ADA IMPROVEMENTS – PHASE 1

**KILLINGLY CENTRAL SCHOOL
22 SOAP STREET
DAYVILLE, CT 06241
STATE PROJECT NO. 069-0067 CV**

DATE: October 18, 2018

End of Addendum ‘2’

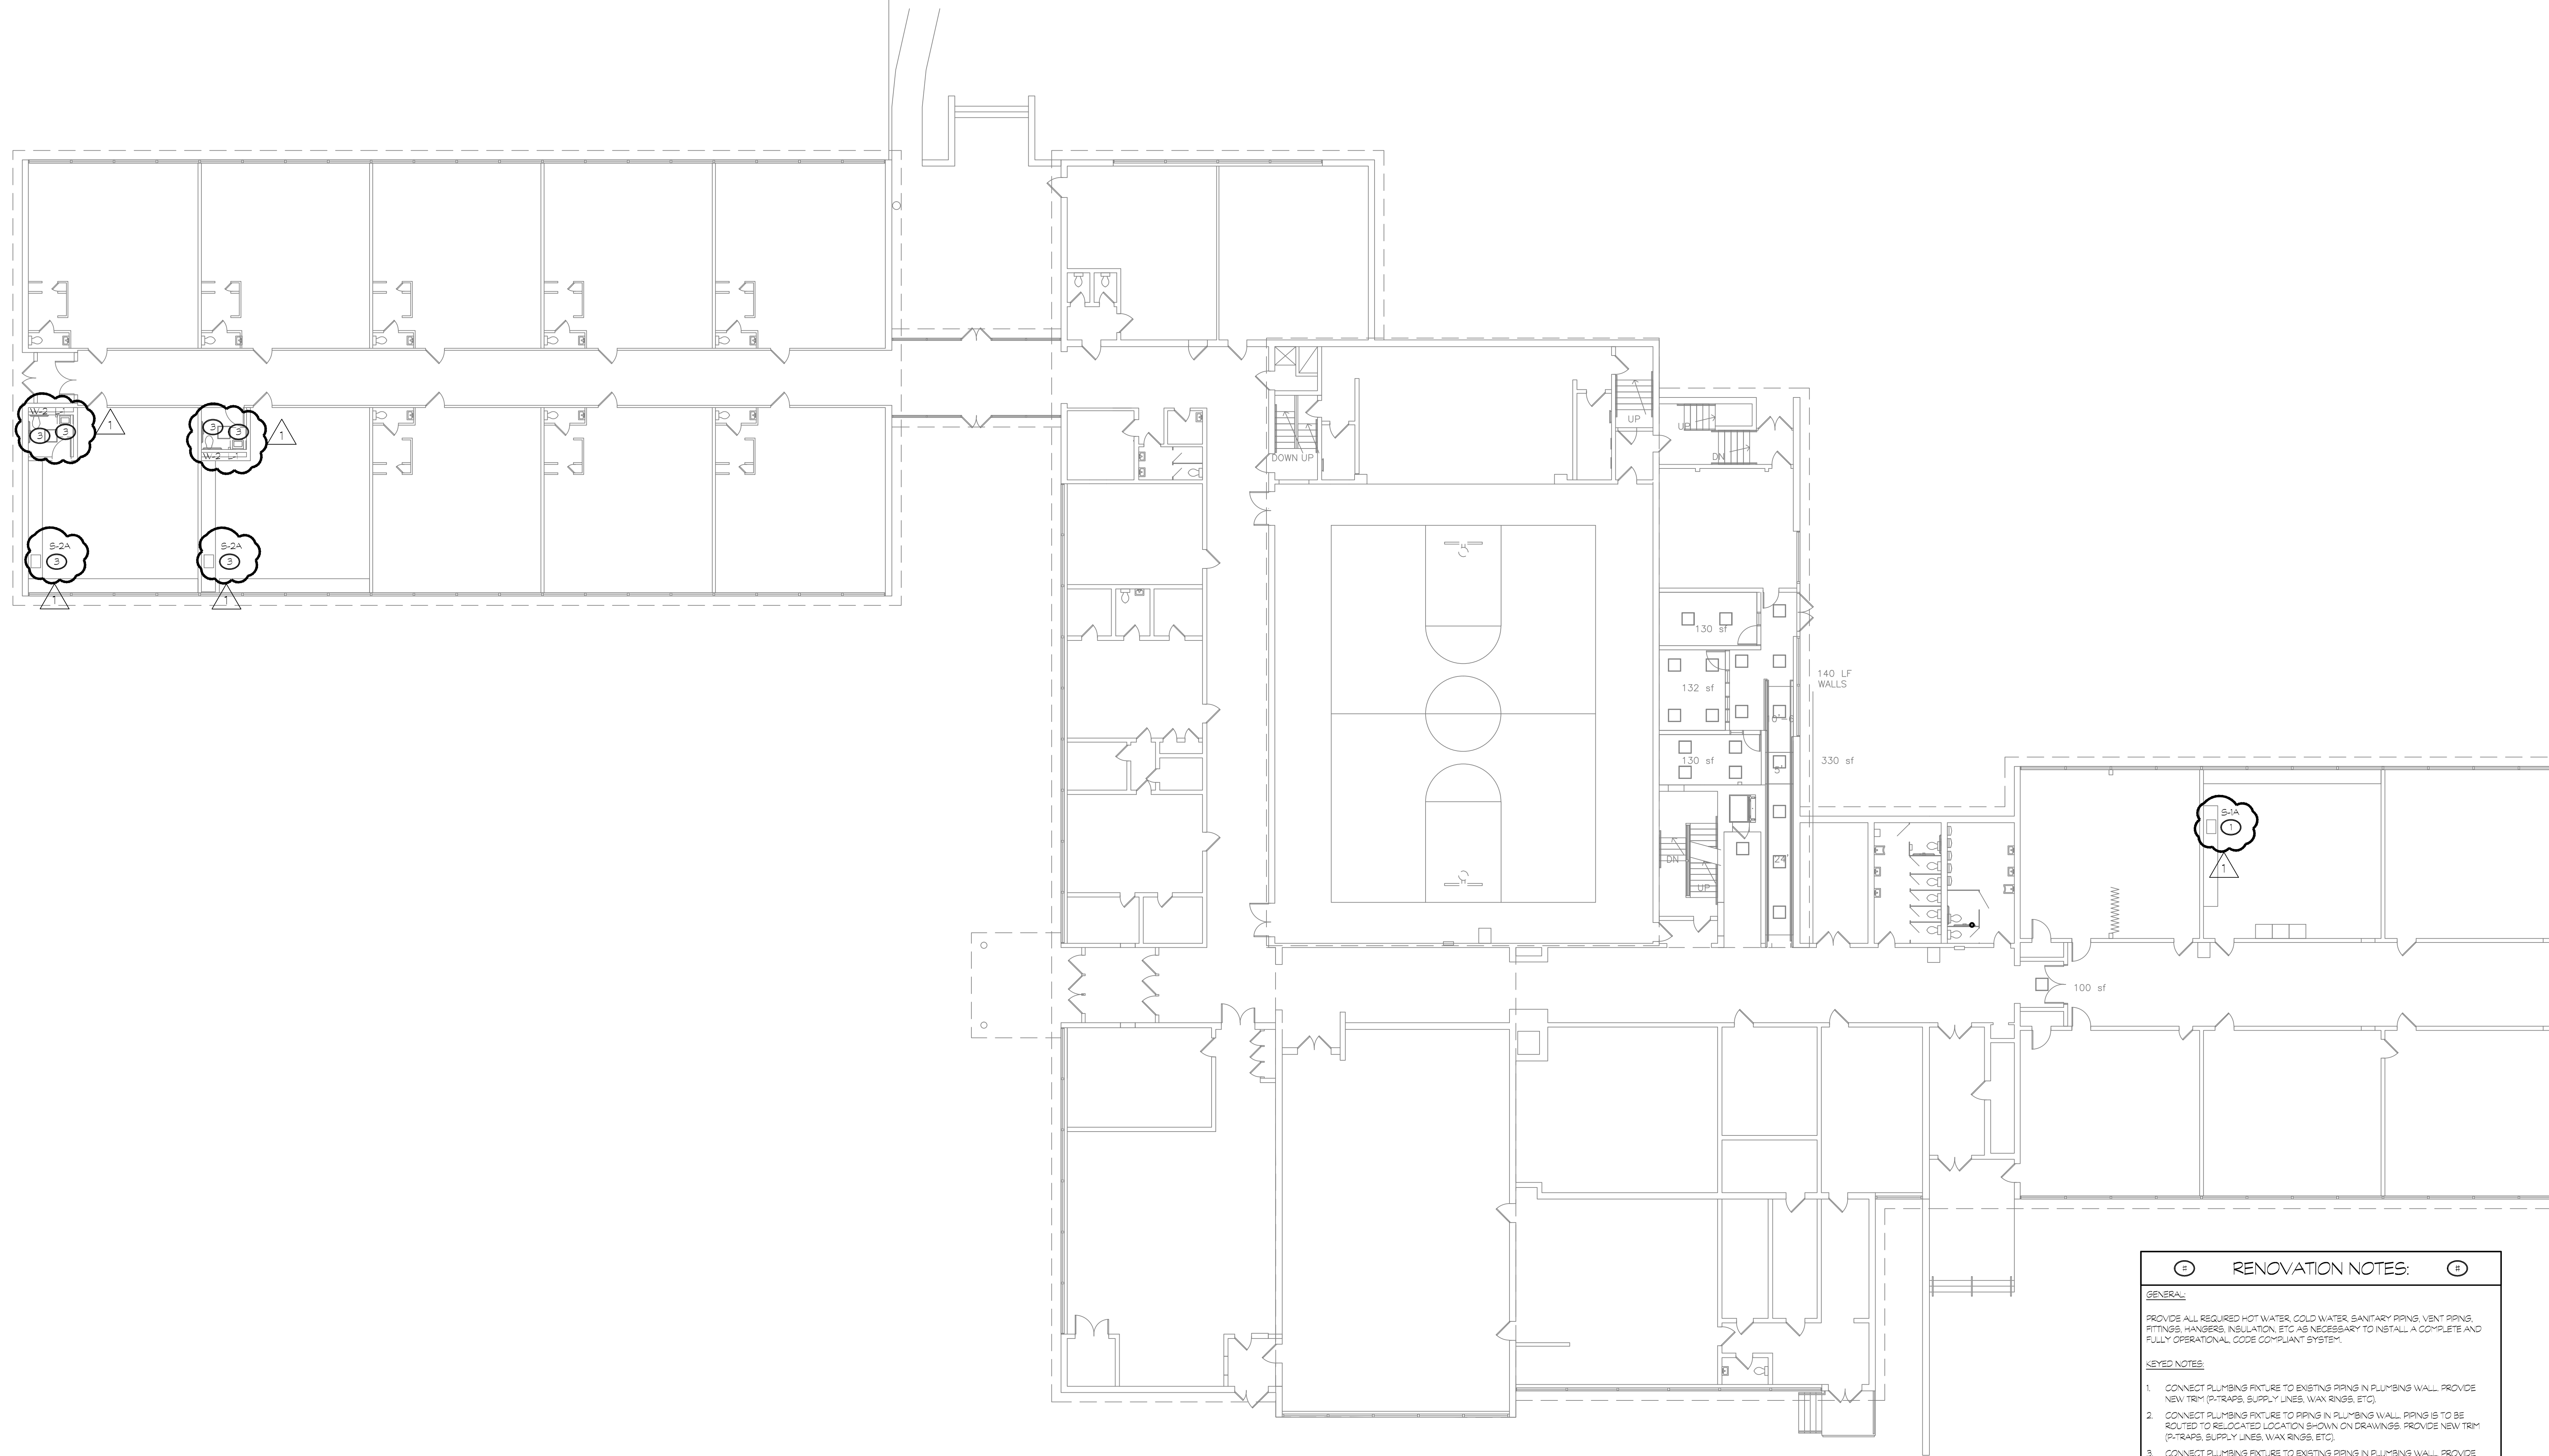
- DRAWING A410, ENLARGED SINK PLANS, ELEVATIONS & DETAILS, Bookcases at Windows Detail @ Classroom D and Wardrobe Detail @ Classroom E, revise “shelf standards” to read “shelf rests”. *(Per Internal Review)*
- DRAWING A411, ENLARGED SINK PLANS, ELEVATIONS & DETAILS, Detail @ Bookcase in Front of Storefront A, revise “shelf standards” to read “shelf rests”. *(Per Internal Review)*
- DRAWING A412, CASEWORK DETAILS, Upper Cab. Det. A and B, revise “shelf standards” to read “shelf rests”. *(Per RFI #002)*
- The following PLUMBING drawings have been deleted in their entirety. New drawings have been added and are attached as part of this addendum*. (3) *(Per RFI #001)*
 - P101 FIRST FLOOR PLAN PLUMBING
 - P102 SECOND FLOOR PLAN PLUMBING
 - P901 PLUMBING SCHEDULES

1. If the contractor decided to perform work during the school year, will there be any associated cost for someone (custodian) to open/oversee/close the schools during off hours such as nights and/or weekends? **-There will be no associated cost.**
2. Both sets of drawings do not label the new fixtures on the plumbing drawings. There are multiple types of sinks and toilets therefore we do not know the quantities of each. The millwork drawings also call for a combination sink & drinking fountain which is not found in the fixture schedule. Are the sinks and drinking fountains in the millwork stainless steel or integral to the solid surface counter? Please advise. **-Plumbing drawings will be updated in forthcoming addendum. Sinks are to be stainless-steel.**
